Whitehall Road Active Travel Scheme

Stage 2 Road Safety Audit

180201-X-X-X-XXX-RP-DBFL-CE-0001

March 2025

Location G3 – Vehicle Tracking

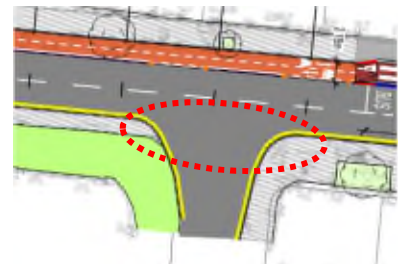
The auditors are concerned that at where junction tightening has been introduced at signal controlled junctions that larger vehicles may have difficulty undertaking their required manoeuvre within the various junctions' footprint which could potentially result in side-swipe collisions with vehicles in adjacent vehicular lanes.

It is recommended that a swept path analysis is undertaken to ensure the appropriate design vehicle movements can be safely accommodated at the altered signal controlled junctions.

Location G5 – Residential dwelling entry widths

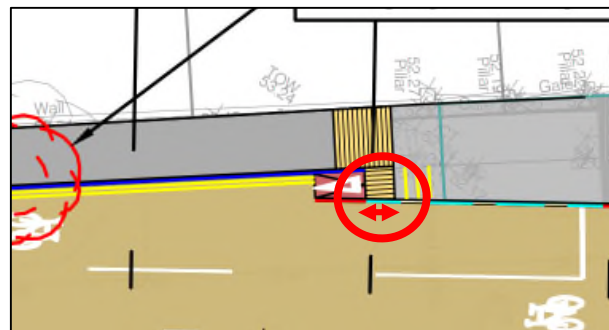
A number of the bollards positioned at dwelling accesses appear narrow. Should these be too narrow to conveniently accommodate a car, this could result in damage to vehicles or

bollards or cause vehicles to undertake a number of manoeuvres to navigate the bollards which could result in rear end shunts.

Bollards should be positioned such that drivers can gain convenient access their driveways without the need for multiple movements.

Location S2 – Proposed Parking Areas -Western Section

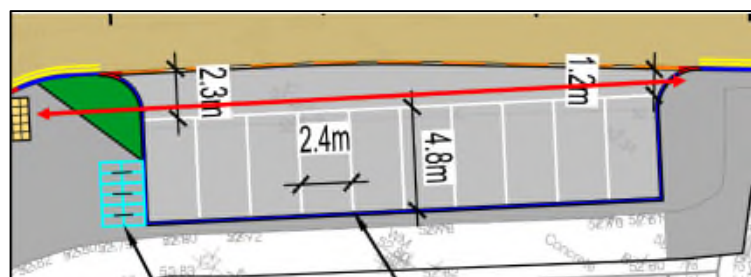
It can be seen on the drawings that a section of parking is being retained for a row of shops by way of a short parallel parking area segregated from the footpath by bollards. Due to the presence of the proposed full height kerb, it is unclear if business owners are permitted to continue to park at the location to the east of the aforementioned parallel parking facility. Should vehicles continue to park informally at this location, this could result in vehicles being parked haphazardly which could result in pedestrian routes becoming blocked / narrowed which could result in pedestrians entering the road to travel

through this area potentially leading to pedestrian / vehicle collisions or could lead to the vehicles parked in the dedicated parallel parking arrangement having difficulty exiting these spaces should their route be blocked by other parked vehicles which could lead to material damage to vehicles.

It is recommended that, should parking be permitted at this location, the parking spaces are formalised and clarified with respect to the routing of pedestrians.

Location S4 – Cycle Parking Spaces

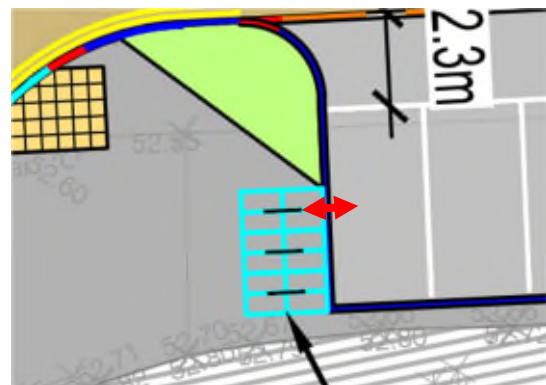
The proposed cycle parking spaces are located immediately adjoining the perpendicular car parking spaces. Failure to provide sufficient space between the cycle parking and vehicle parking could result in material damage to bicycles should they be located within the parking vehicles swept path or door opening areas.

Cycle parking stands should be positioned an appropriate distance from car parking spaces.

Location S5 – Cycle transition into Shared Area

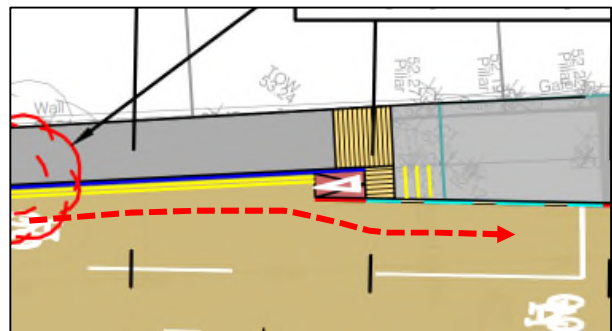
The road kerb line suddenly ends with a cycle facility into the shared area. Drivers may not expect this sudden change particularly in poor visibility, which could lead to vehicles mounting the kerb and entering the shared area. This may cause collisions between vehicles and pedestrians or cyclists.

It is recommended that measures incorporated to guide drivers away from the cycle transition into the shared pedestrian / cycle facility.

Appendix A : Stage 2 RSA Problem Map

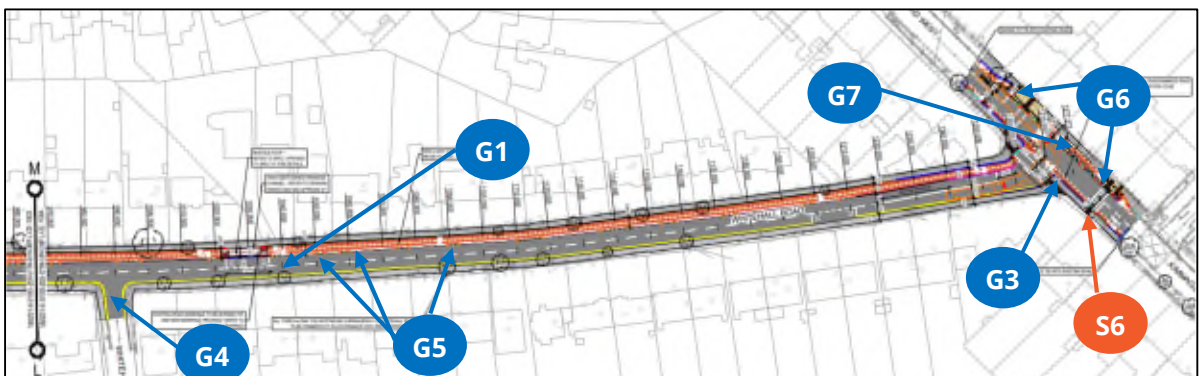
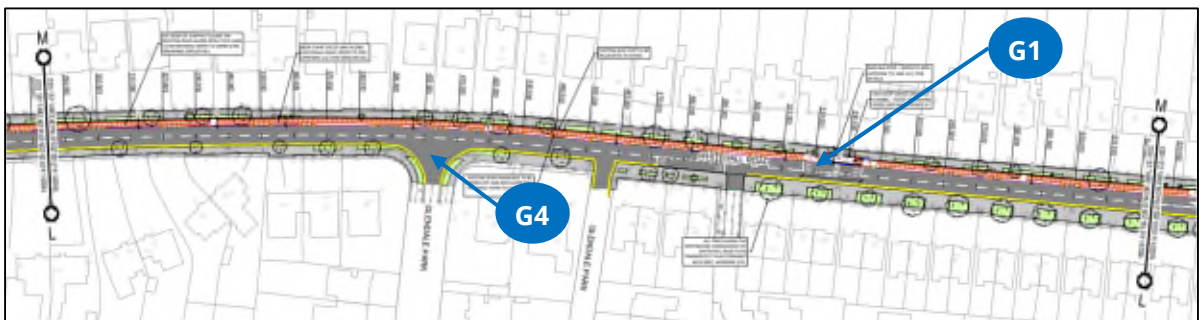
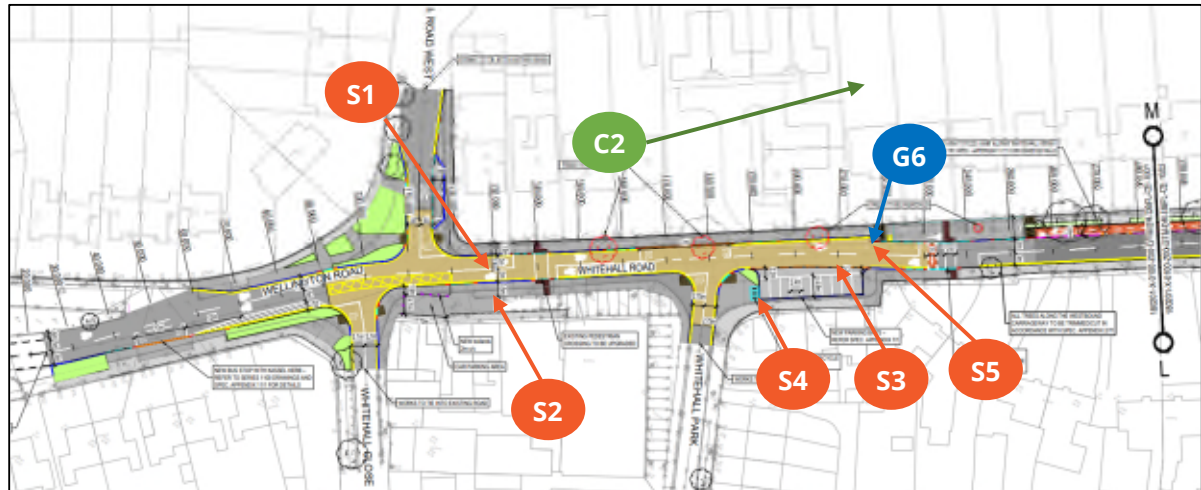
- G General problem at multiple locations (sample of problems shown only)
- S Problems at specific locations
